ISO/IEC FDIS 14443-2:2009(E)

Identification cards — Contactless integrated circuit(s) cards - Proximity cards — Part 2: Radio frequency power and signal interface

Document stage: (50) Approval

Figure 3 — PauseA for a bit rate of $fc/128$

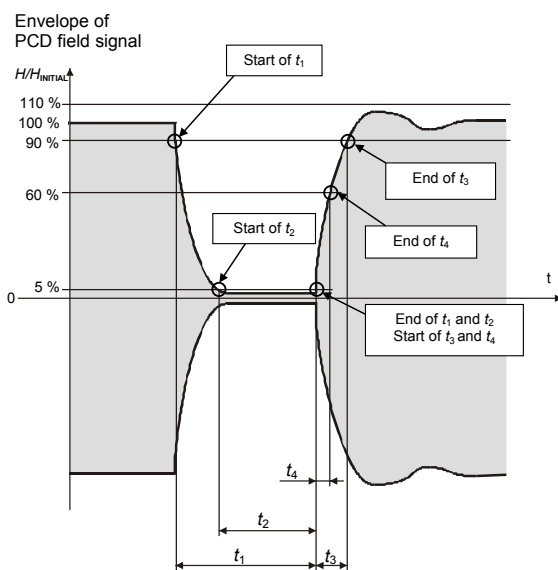
Comentado [r1]: Modif t4 and t2 !!

Comentado [r2]: Modif t2 and t4

Figure 5 — End of PauseA for a bit rate of $fc/128$

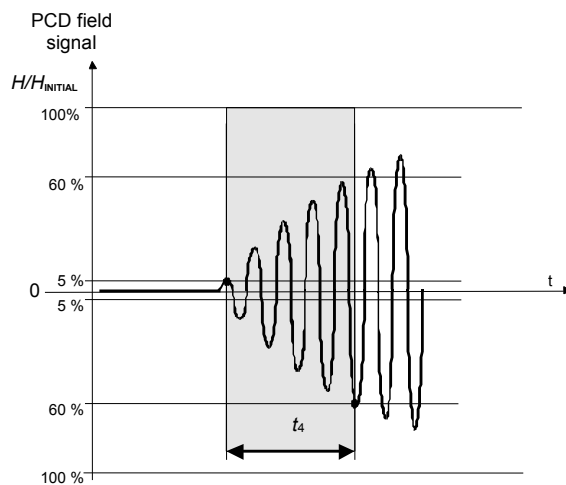
Comentado [r3]: The triangle on the left side will be copied to the right side, 45° degree
